TFGP-01-04

GRE Task Force Glare Prevention

Status paper for GRE Task Force "Glare Prevention"

Draft version 1, 6. April 2025

Annex 5

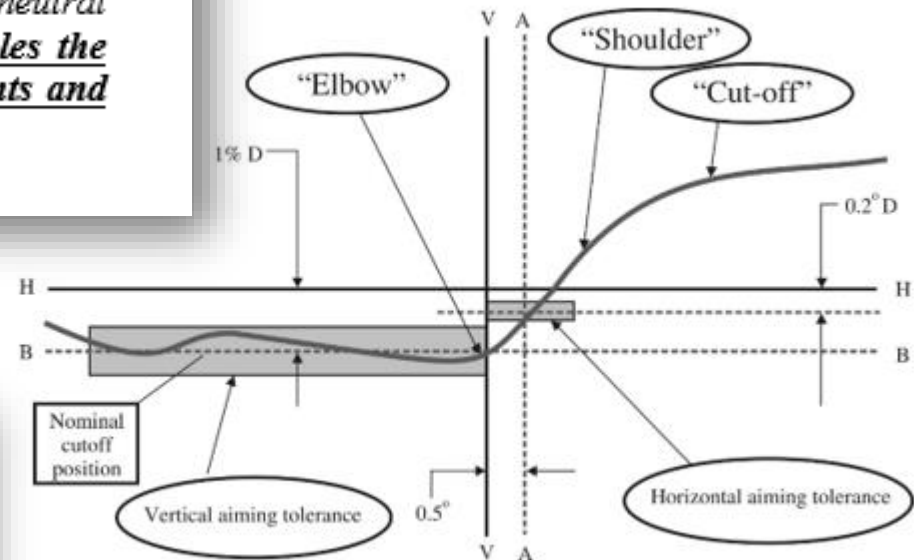
- It should be guaranteed, the particular precision of aiming in static conditions and the cut-off line shall meet this expectation in the annex 5 point 1.1. But "straight" part on the left is not straight on the picture, and an "Elbow" is not clear point which is possible to properly set. Definition should be clear and allowing to be practically verified by the measurement and/or translated to digital evaluation algorithm. There is no guarantee, that the current definition will lead to a clear and repeatable headlamp aiming.

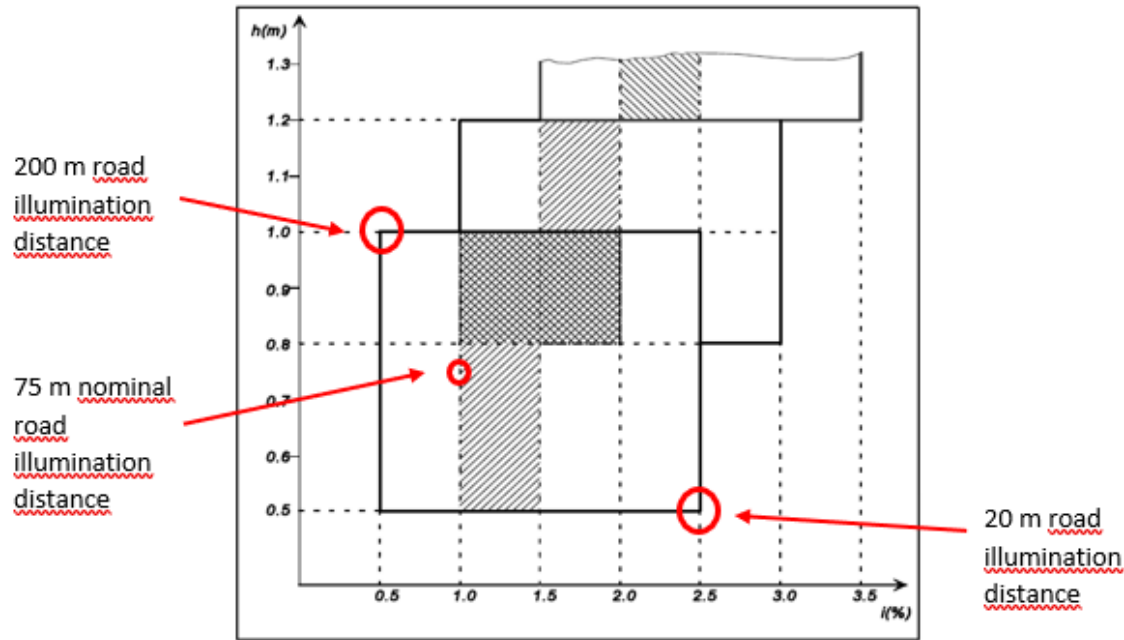
Another mistake in the regulation is the possibility to change the aim during the type approval test. This means that the headlights cannot be aimed correctly in cases of in-use conditions (after TA), because aligning them according to cut-off line may then result in different road illumination and possible glare in traffic. The point 1.2.3 de facto excludes the possibility for correct headlight aim adjustment according to UENECE R149, Annex 5, point 1.1. see the intro.

~~1.2.3. Where a headlamp or AFS so aimed does not meet the requirements set out in paragraphs 5.2. to 5.4. of this Regulation respectively, its alignment may be changed, provided that the axis of the beam is not displaced:~~

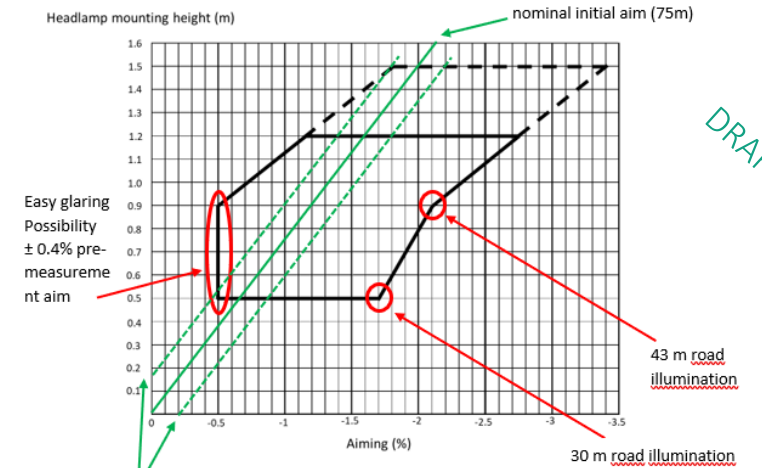
The next problem is the initial aiming/leveling tolerances. Both, the currently required range of leveling and the new conditions that require automatic leveling are unacceptable.

Present range of the road illumination allows to set it from 20m up to 200m, (nominal is 75m).

Initial aim can be anywhere in the "box". No requirements regarding precision of automatic leveling.

Technically feasible automatic leveling tolerances $\pm 0.2\%$ (based on real tests on M1 vehicles in Karlsruhe in 2022 during SLR group meeting).
